PRE BID QUERY – REPLY & CORRIGENDUM-1 & 2

Subject :Tender for Proposed Construction of New Branch cum Residential building in the place of existing Indian Bank Velachery Branch after Demolition of old building at Velachery Main Road, Velachery, Chennai- 42

Reply to the queries during Pre bid meeting held on 01.09.2021 of bidders

SKETCH -1

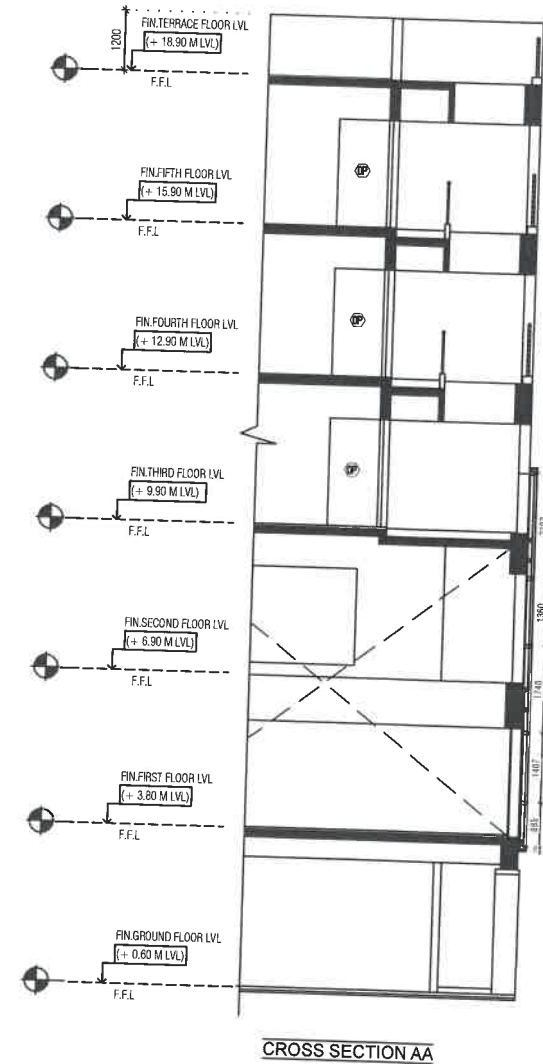
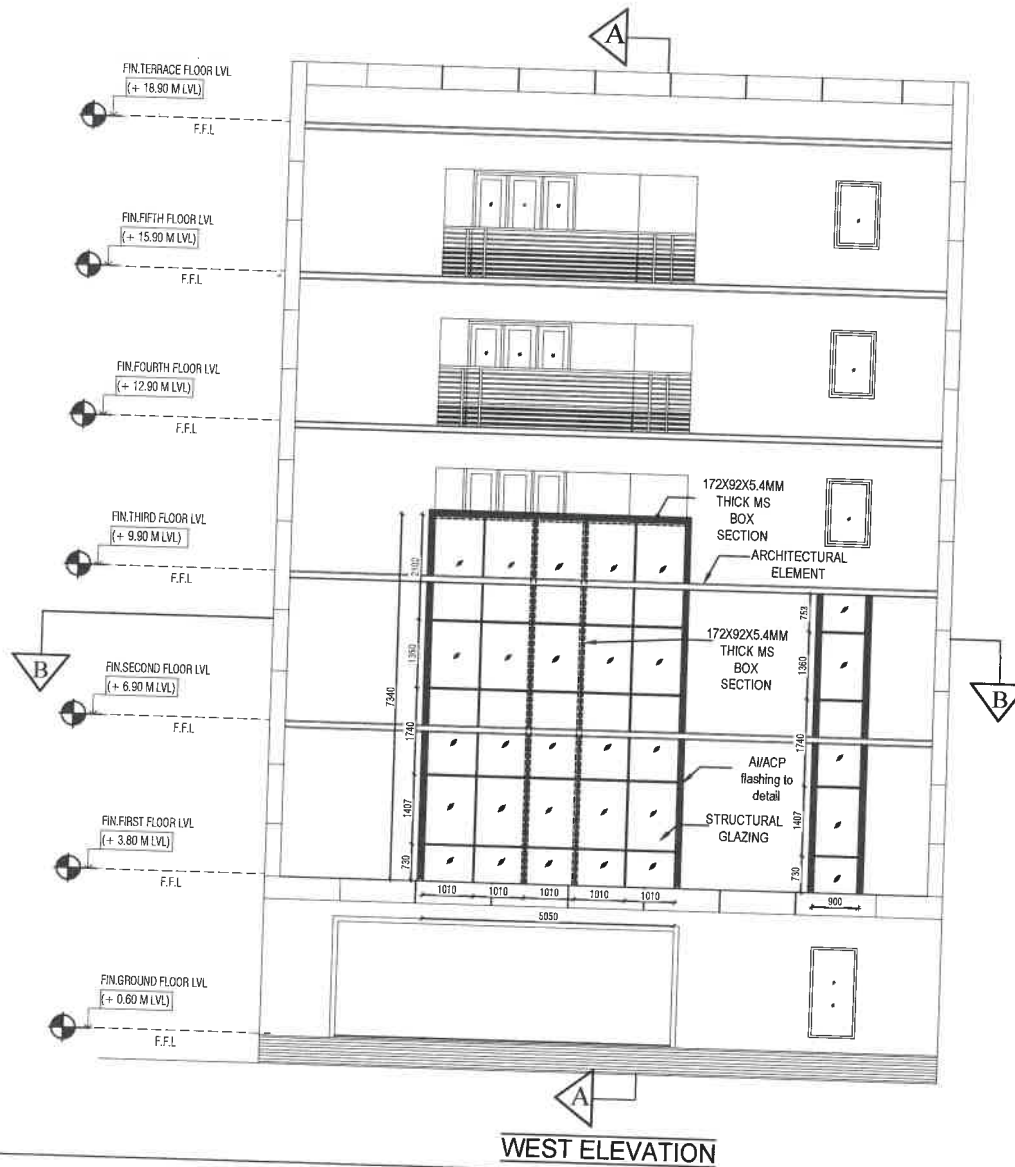
12	General:	Bricks : 75 Class designation bricks are not available in the market. Hence, 50 Class designation may considered.	Yes. Class 50 Bricks with minimum compressive strength of 5 N/mm ² and water absorption less than 15%, can be used for brick works.
13	Price Bid, Volume – II	Joinery : (i)15(a) -Thickness of plank not mentioned. (ii)15(b) -Thickness of flush shutter is 38mm overall or excluding lamination. (iii)16(g) -Aluminum channel and louvers sizes are not mentioned.	(i) Finished thickness of Panel / Plank shall be 30 to 32 mm. (ii)Thickness of flush door shutter shall be 38mm, excluding the thickness of laminate. (iii)Refer attached Typical Aluminium Louver Drawing (Sketch No.1).

CONCEPT DRAWING

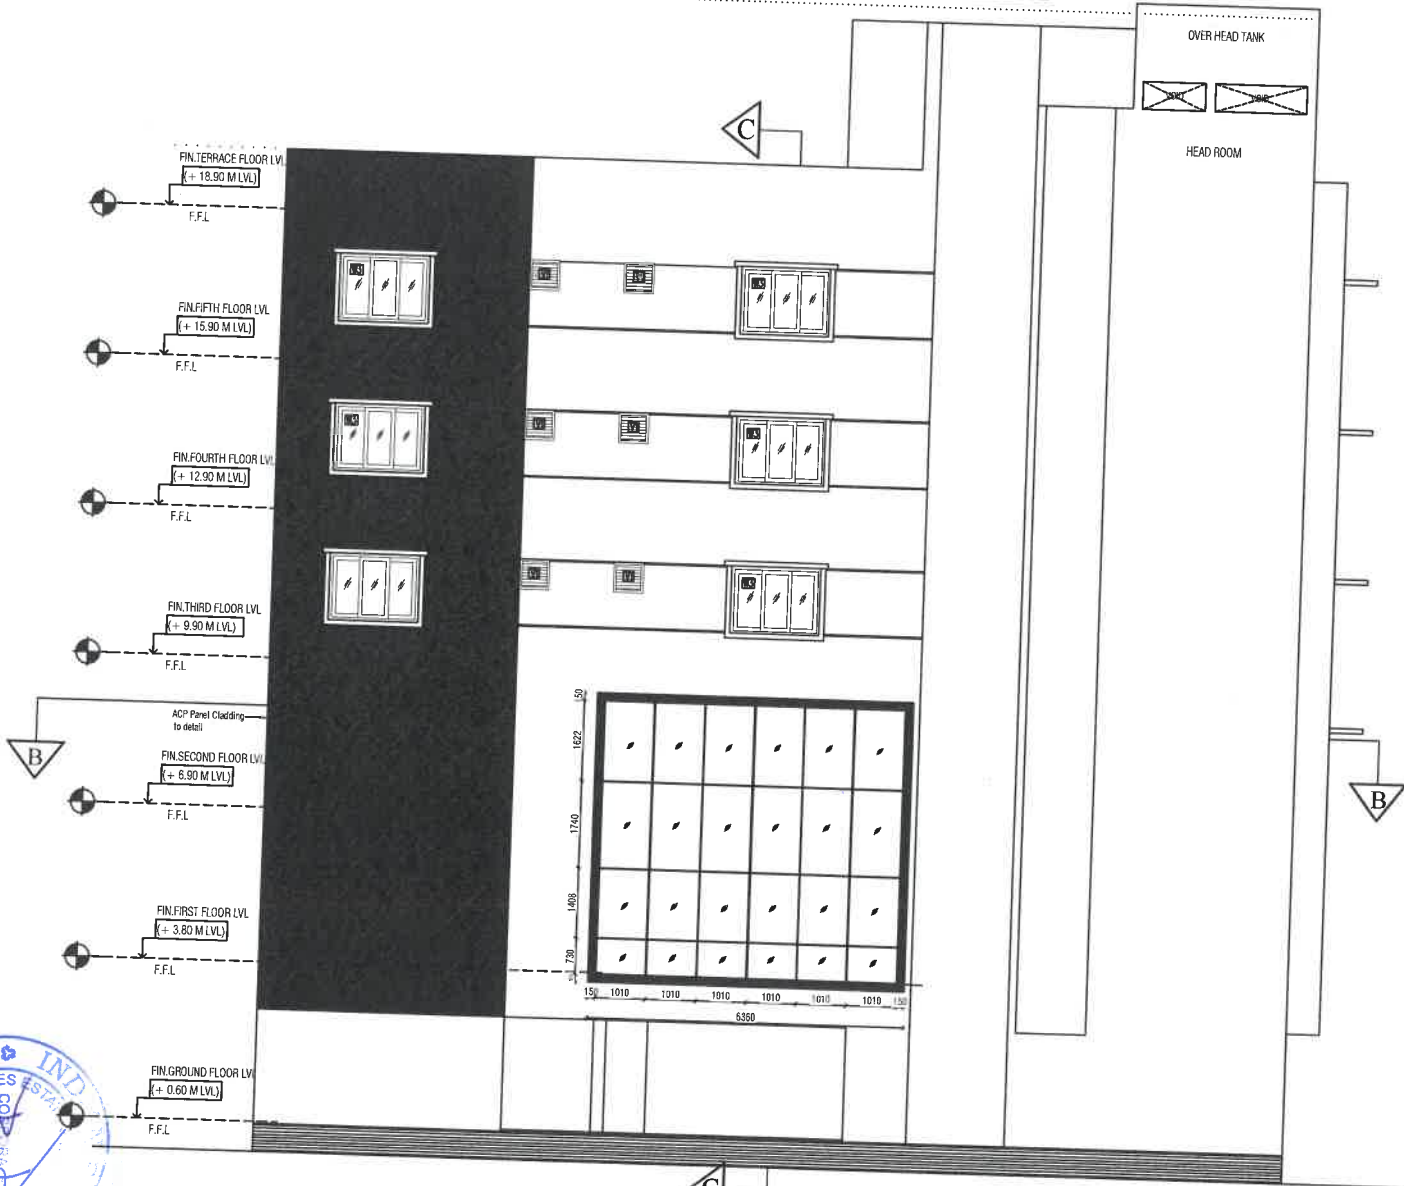
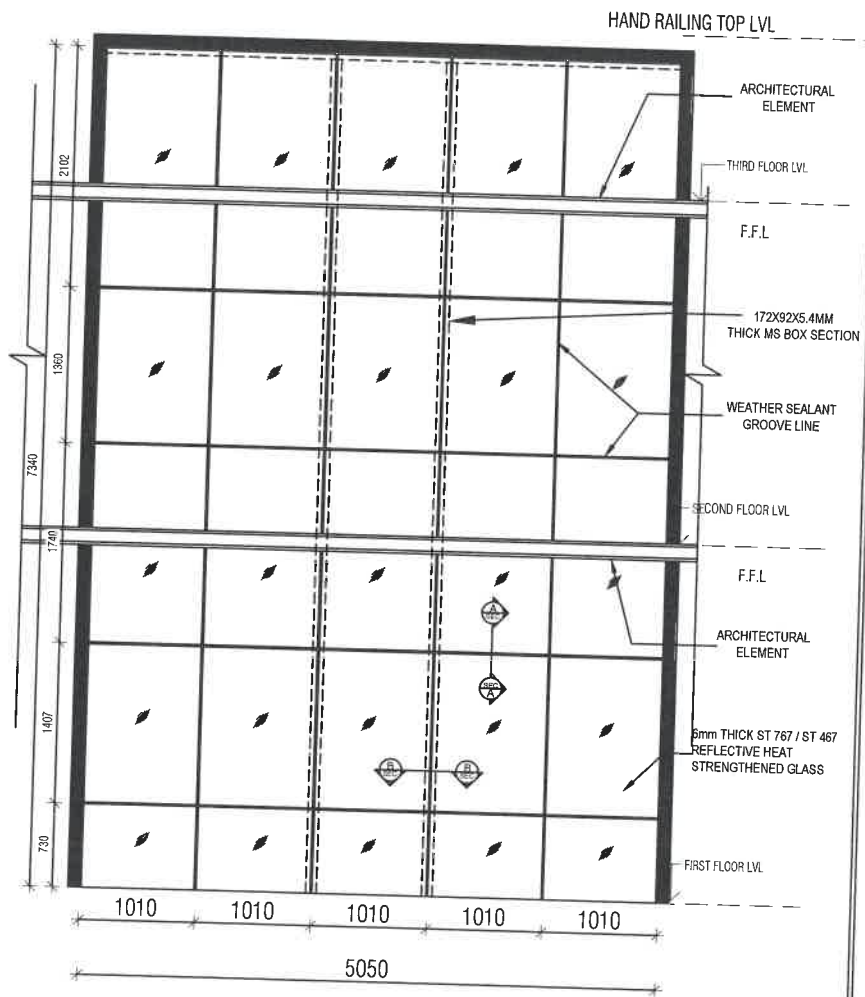
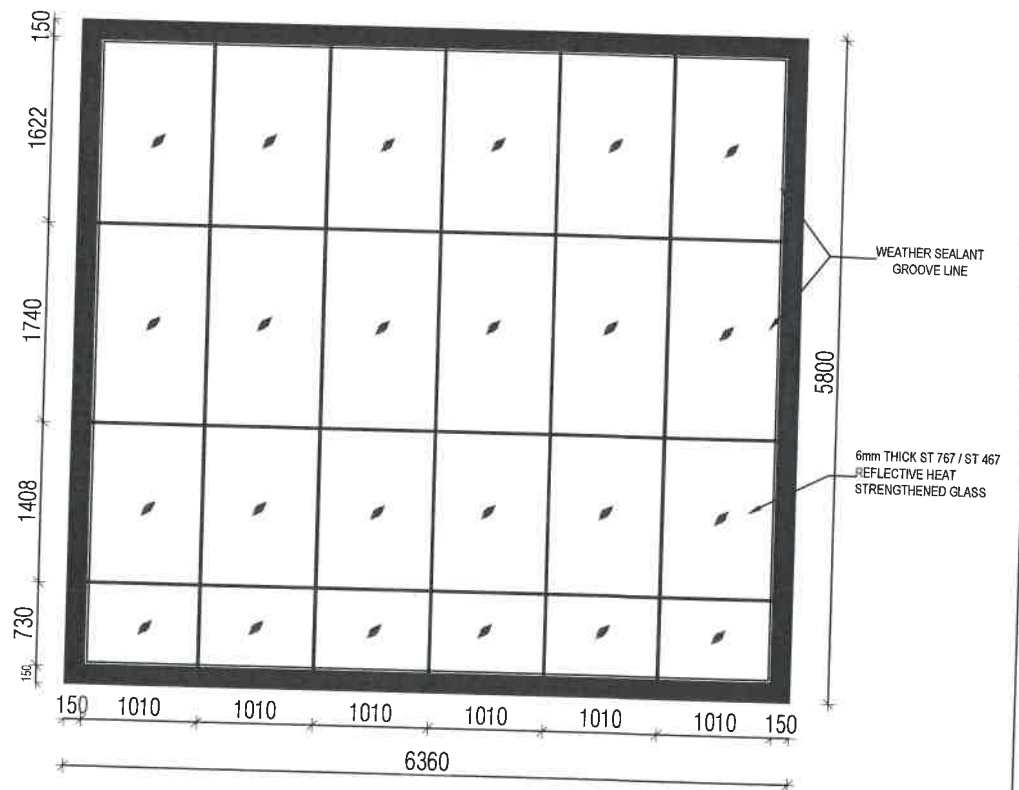
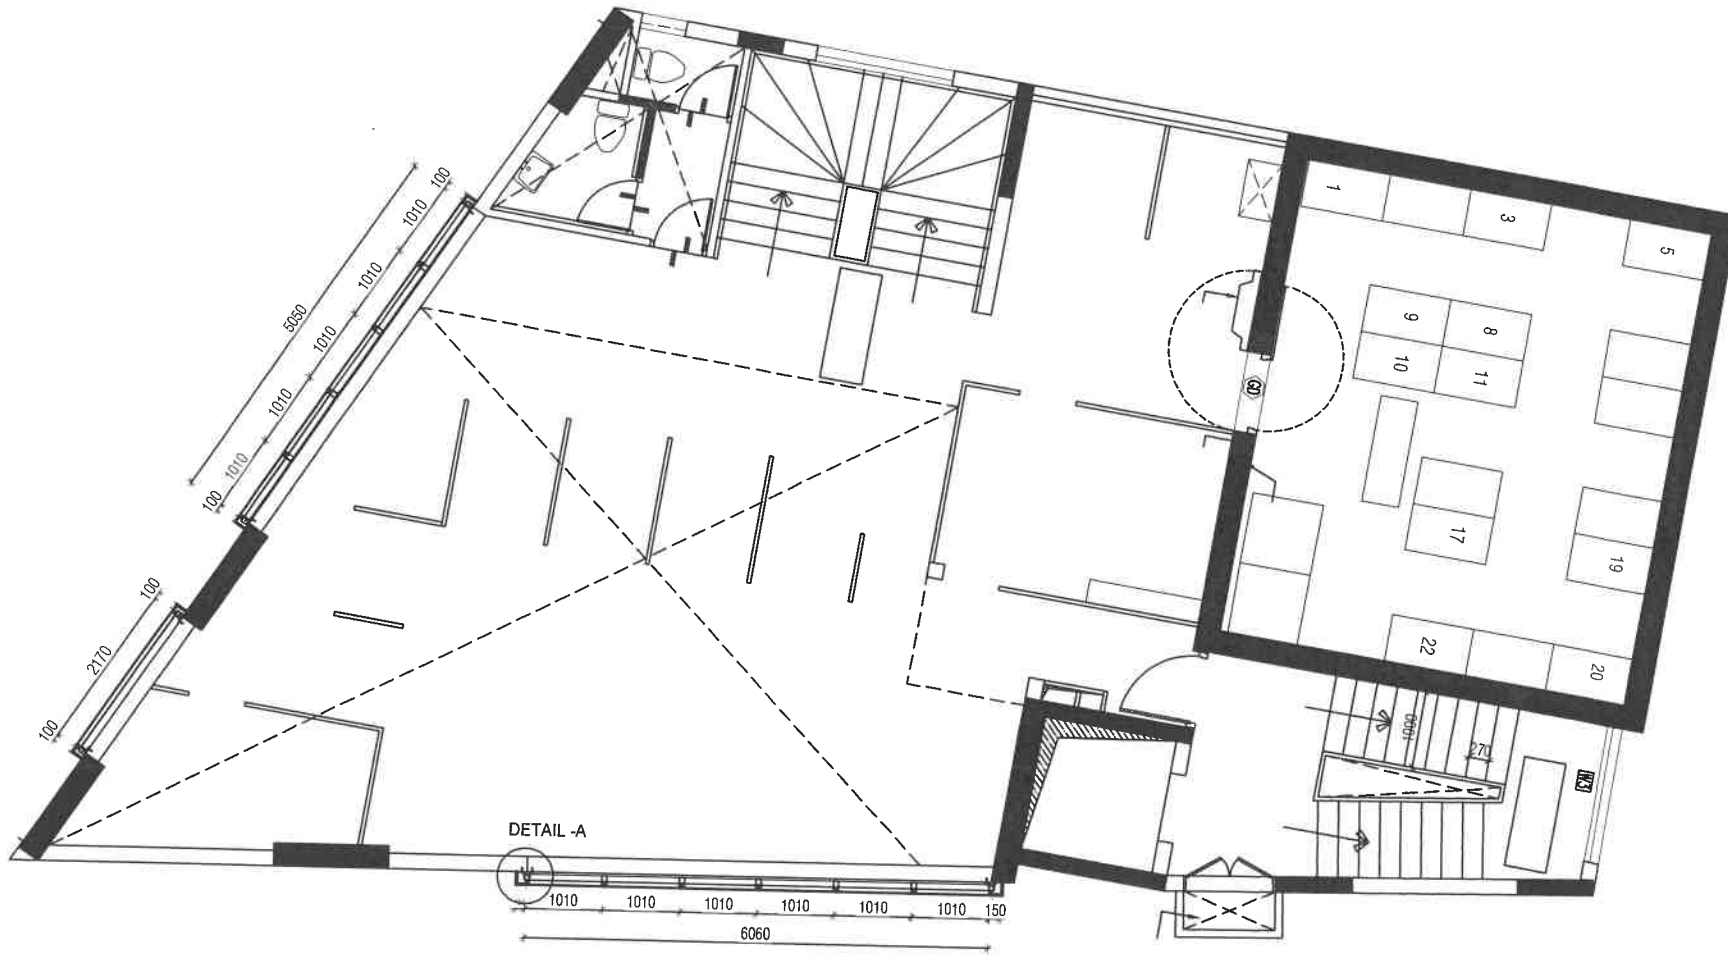
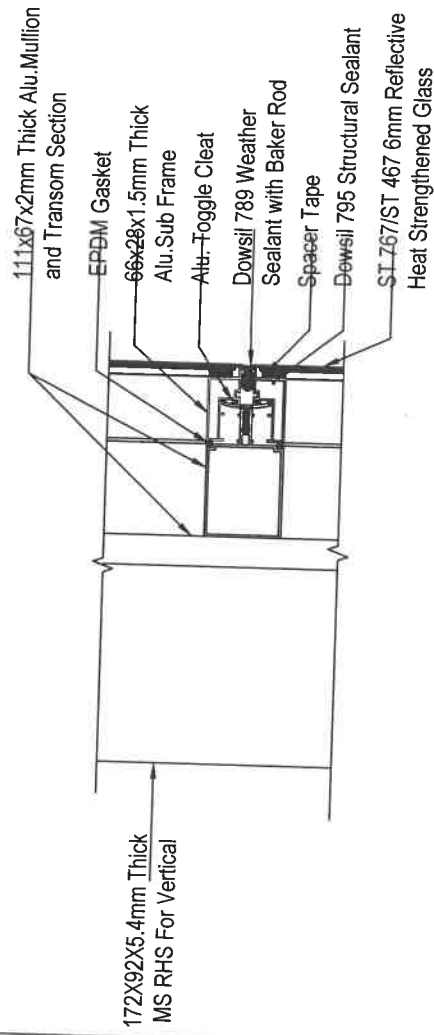
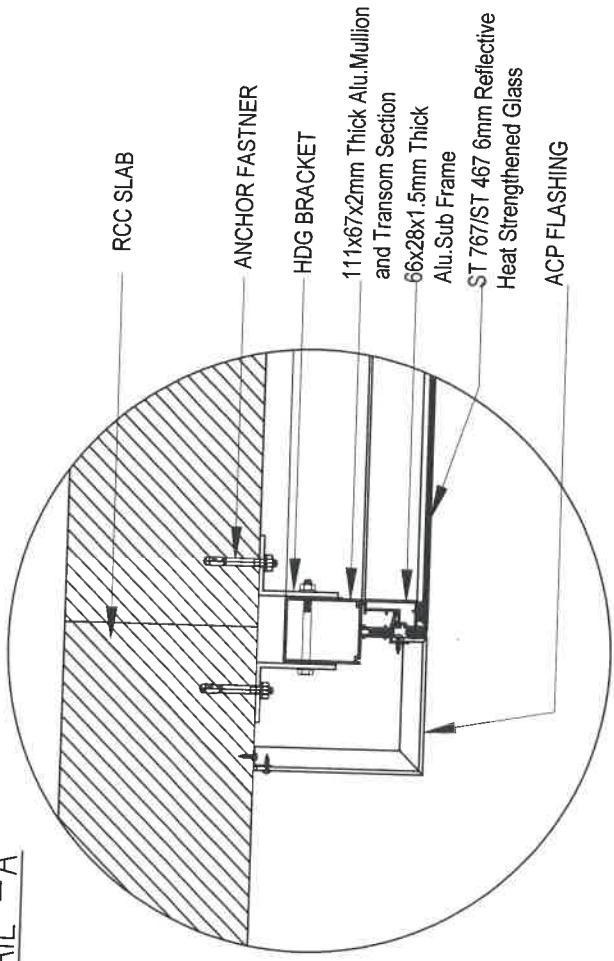
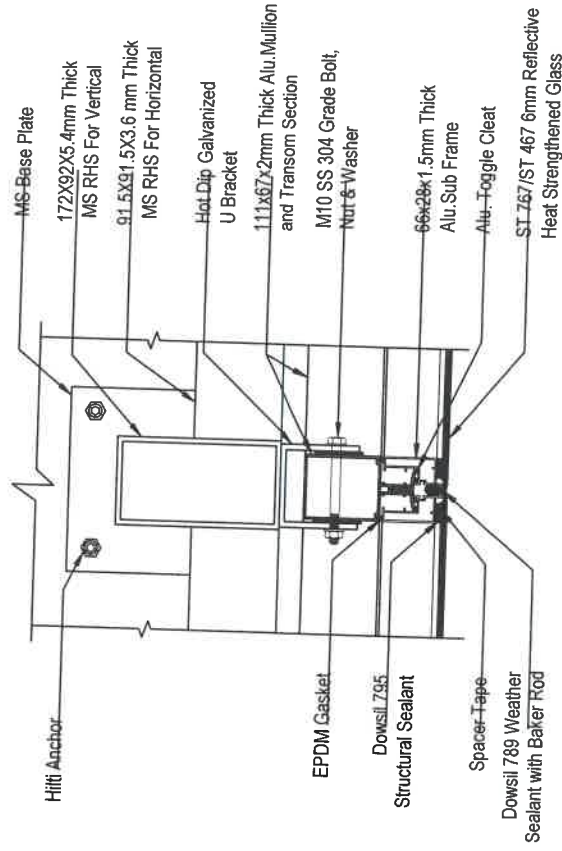
SI No	Clause in Bid Documents	Query raised by the bidders	Bank's Reply
14	Price Bid, Volume – II Item No.12.03 - Structural Glazing	Structural Glazing : Steel support structure vertical members and horizontals space is not Mentioned. But in item No.13m provision is made. Can we quote glazed items excluding structural work.	Please refer Corrigendum-1 for structural glazing specification – item No:12.03 Regarding Item No.13m which is a separate item intended for front side elevation work.
15	Price Bid, Volume – II	Flooring tiles : Please confirm whether to provide spacer (or) not so that correct rate can be quoted.	Vitrified tile flooring shall be laid with Paper Joint. Anti skid Ceramic tile flooring in toilets shall be laid with suitable spacer.
16	Technical Bid, Volume – I	Whether Proforma - VII (Performance Report) is required to be submitted with signature from client / department. Already client issued the completion certificate with performance in client's letter head.	Yes. Proforma VII to be submitted as per the stipulated format. In case, if the client already issued completion certificate in line with the Proforma VII requirements, the same will be considered.

SI No	Existing item in Price bid- Volume-II	Amended item in Price bid- Volume-II	Remarks
1	<p>Item No. 12.03 STRUCTURAL GLAZING (In Front Elevation)</p> <p>Double height semi unitized glazing with single glass;</p> <p>Providing and fixing of double height structural glazing (semi unitized system – all panels fixed) for a span of 6.3 meter height, using 15 microns colour anodized Jindal/equivalent aluminium main frame of size 111x67x2mm section for verticals and horizontals, designed to withstand wind pressure up to 180 kg/sq.m. using necessary aluminium/GI angle cleats with slots for adjusting plumb, fixed to the RCC slabs with M10 Hilti expansion fasteners and fixing hermetically sealed double glass, consists of 6mm thick ST 767 (Blue Ray) / ST 467 (Emerald Glaze) reflective heat strengthened glass + 12mm air gap + 5mm thick clear toughened glass, The glazed panels shall be made using 66x28x1.5mm section for sub frame, with using double side cross linked polyethylene spacer tape and structural sealant (Dowsil 795) in such a way as to transfer the dead weight of the glass on to the mainframe so as to avoid undue stress on the structural sealant. The glazed panels after suitable curing in dust free environment shall be fixed on to mainframe from the exterior (this system enables easy replacement of glass in future (if any breakage) from the outside especially in spandrel areas). The grooves shall be closed with weather grade silicone sealant (Dow sil 789). It shall be ensured that the whole system uses corrosion</p>	<p>Item No. 12.03 STRUCTURAL GLAZING (In Front Elevation)</p> <p>“Semi unitized structural glazing with Double glass for the Double height lobby;</p> <p>Providing and fixing of continuous structural glazing (semi unitized system – all panels fixed) for unsupported span of not more than 2.5 meter height, using 15 microns colour anodized Jindal/equivalent aluminium mainframe of Jindal extrusions, size 111x67x2mm section for verticals and horizontals, designed to withstand wind pressure upto 180 kg/sq.m. using necessary HDG steel brackets with slots for adjusting plumb, fixed to the RCC slabs with M10 Hilti expansion fasteners, the outer frame shall be connected using M10 SS 304 grade connecting bolts, nuts and washers. The glazed panels shall be made using 66x28x1.5mm section for sub frame, glazed hermetically sealed double glass, consists of 6mm thick ST 767 (Blue Ray) / ST 467 (Emerald Glaze) reflective heat strengthened glass + 12mm air gap + 5mm thick clear toughened glass with using double side cross linked polyethylene spacer tape and structural sealant (Dowsil 795) in such a way as to transfer the dead weight of the glass on to the mainframe so as to avoid undue stress on the structural sealant. The glazed panels after suitable curing in dust free environment shall be fixed on to mainframe from the exterior (this system enables easy replacement of glass in future (if any breakage) from the</p>	<p>Contractor is requested to note the amendment. The same amendment has been incorporated in the Price Bid for the particular item in tender wizard website. There is no changes in the Quantity of the particular item.</p>

<p>resistant hardware, is totally weather proof, permits necessary thermal expansion/contraction and is able to withstand relevant wind loads.</p> <p>The glazing system shall be supported by a steel support structure, using 172 x 92 x 5.4mm RHS for verticals and 91.5 x 91.5 x 3.6mm SHS for horizontal with required MS base plates and Hilti anchors, finished with anti corrosive zinc primer and PU paint of approved colour. The glazing shall be extended to next level and terminated at hand railing level. The glazing top shall be connected to the SS railing. The rate shall include the cost of MS support structure and the SS hand railing with balusters and the connecting arrangements. NOTE: The work should be executed by specialist contractor as approved by Architect / Bank complete.</p>	<p>outside especially in spandrel areas). The grooves shall be closed with weather grade silicone sealant (Dow sil 789). It shall be ensured that the whole system uses corrosion resistant hardware, is totally weather proof, permits necessary thermal expansion/contraction and is able to withstand relevant wind loads.</p> <p>The glazing system shall be supported by a steel supports, using 172 x 92 x 5.4mm RHS for verticals with required MS base plates and Hilti anchors, finished with anti corrosive zinc primer and PU paint of approved colour. The glazing shall be extended to next level and terminated at hand railing level. The glazing top shall be connected to the SS railing. The rate shall include the cost of MS support structure and the SS hand railing with balusters and the connecting arrangements."</p> <p>Details of steel support structure vertical members is provided in the attached drawing. The rate quoted for the item shall be inclusive of the cost of steel support structure (Drawings attached).</p>
